AMENDMENTS TO THE DRAWINGS

REMARKS

Fig. 1

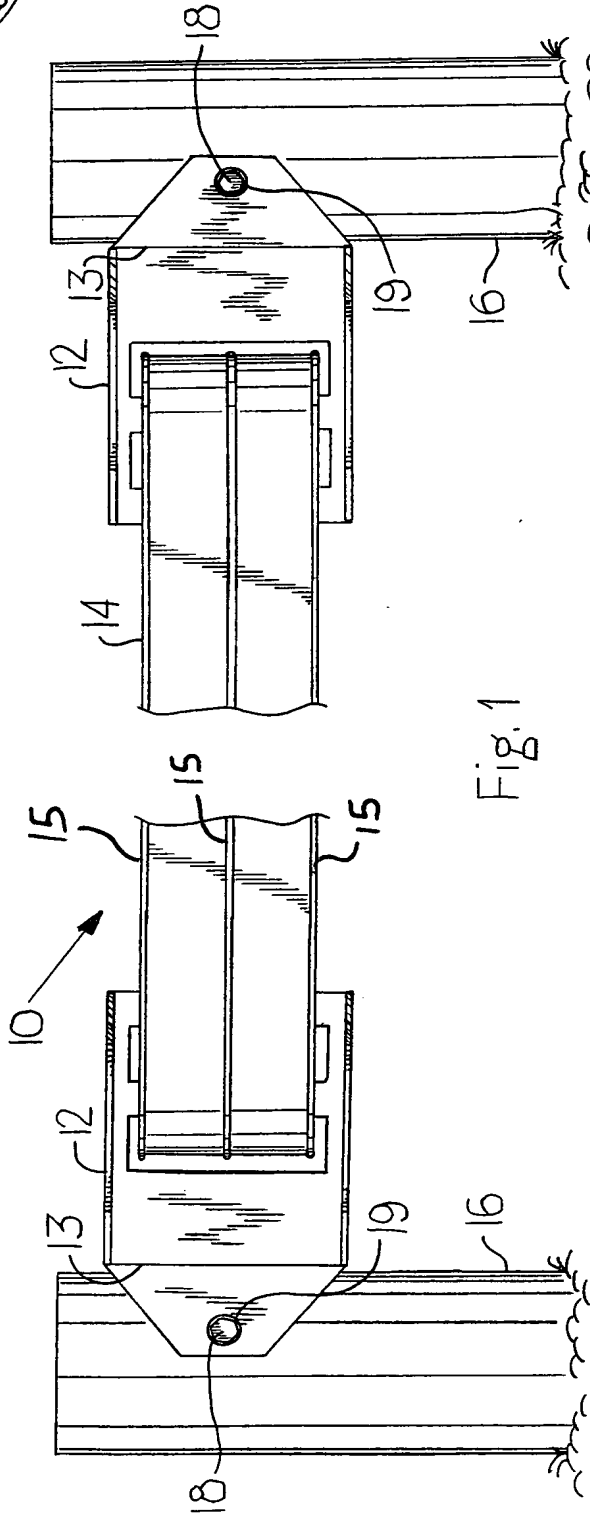
In the specification, paragraph number [0019] has been amended to reference newly added element number '15' in FIGS. 1, 2, and 4 that indicates the metal wires ensheathed in the plastic of the rail. Additionally, the metal wires have been drawn in phantom in FIG. 4. The metal wires have not been drawn in the other figures, as such additions would be duplicative. FIGS. 3-4, 6-7, and 9-14 have been amended to remove the cross-hatching therefrom.

The drawings stand objected to because the cross-hatching is incorrect. Pursuant to 37 C.F.R. §1.84(h) hatching is to be used for sectional views, of which there are none shown in the instant application. As there are only perspective views present, the Applicant has removed the hatchings from the drawings. The Applicant believes that new FIGS. 1, 2, and 4 overcome this particular objection. The drawings also stand objected to for not specifically showing the metal wires referred to in the specification. As indicated in the specification, the metal wires are ensheathed in the plastic portion of the rail. The Applicant believes that new FIGS. 3-4, 6-7, and 9-14 overcome this particular objection. Amendments to FIGS. 1-4, 6-7, and 9-14 are indicated in red in the attached annotated copy of FIGS. 1-4, 6-7, and 9-14. Reconsideration of these objections is respectfully requested.
